Central
Air Conditioning Co., Inc.
Mechanical Contractors

ADDITION TO A PART OF
DIST. M. S. S. NO. 12
CITY OF WICHITA, KANSAS
PROJECT NO. DRAW 205 P. 2

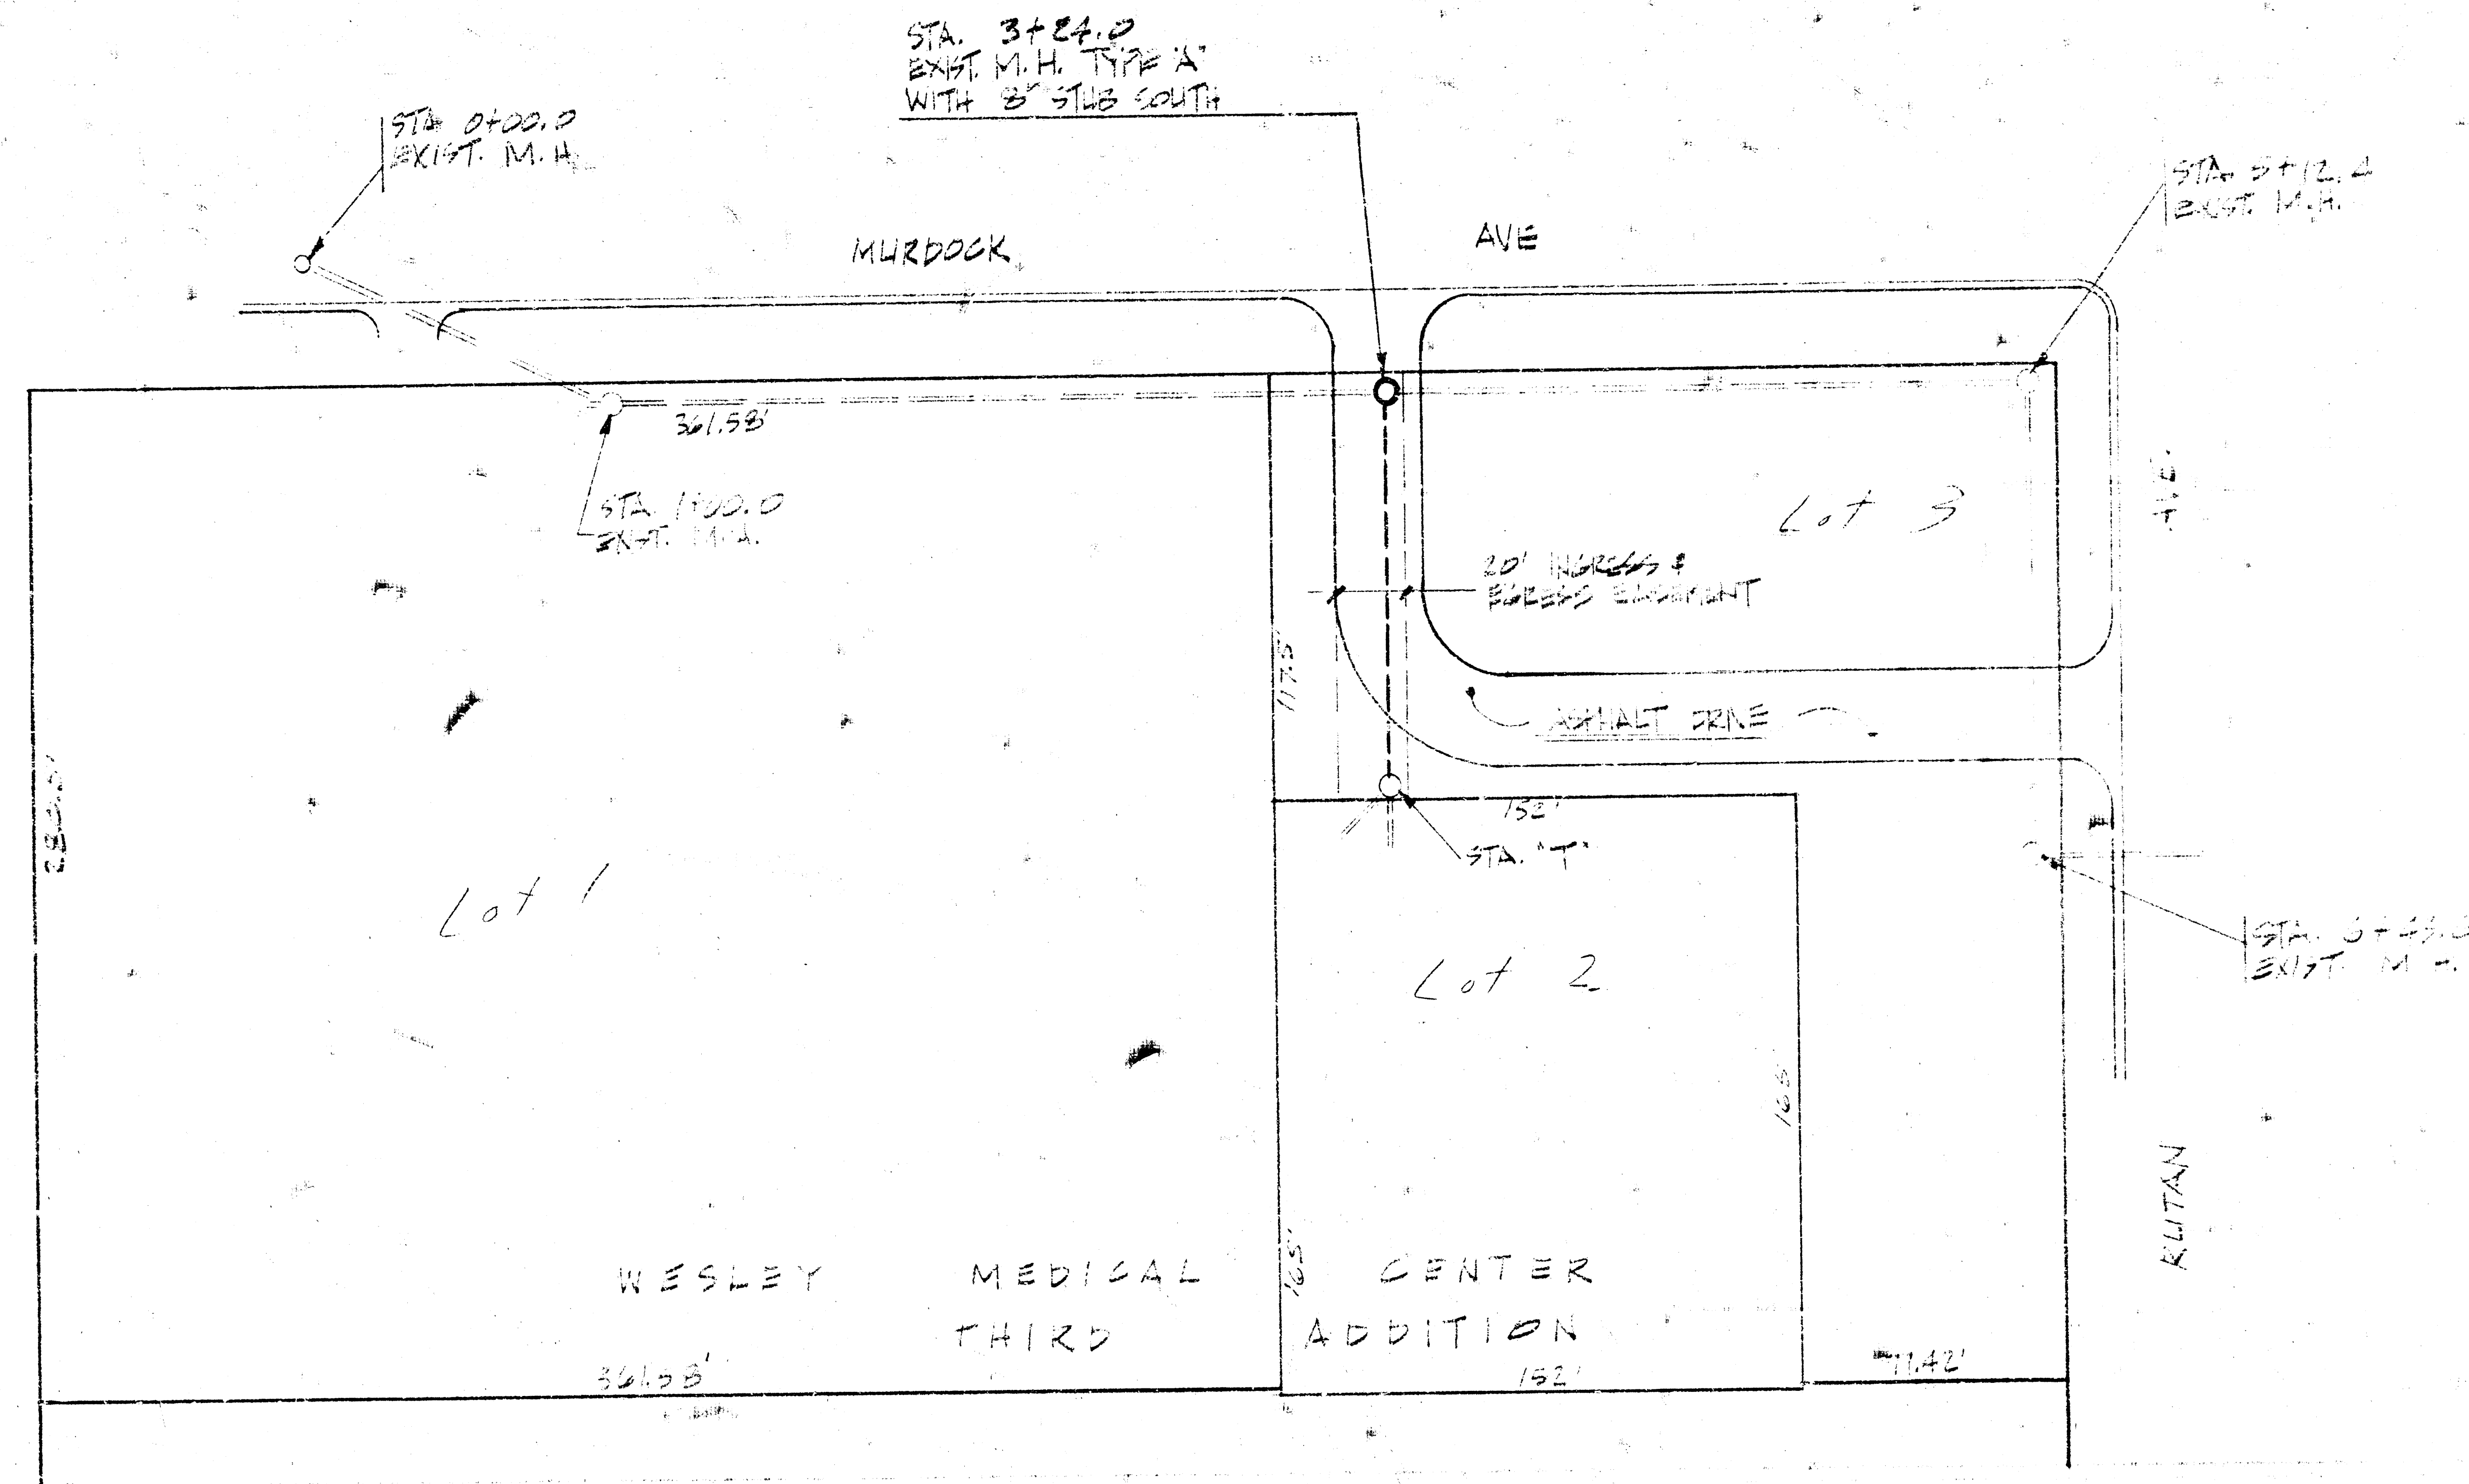
7-9-75
APPROVED AS NOTED
BY CITY ENGINEER OF WICHITA
Sanitary Sewers D.E.S.
Storm Sewers _____
Driveway Approaches _____
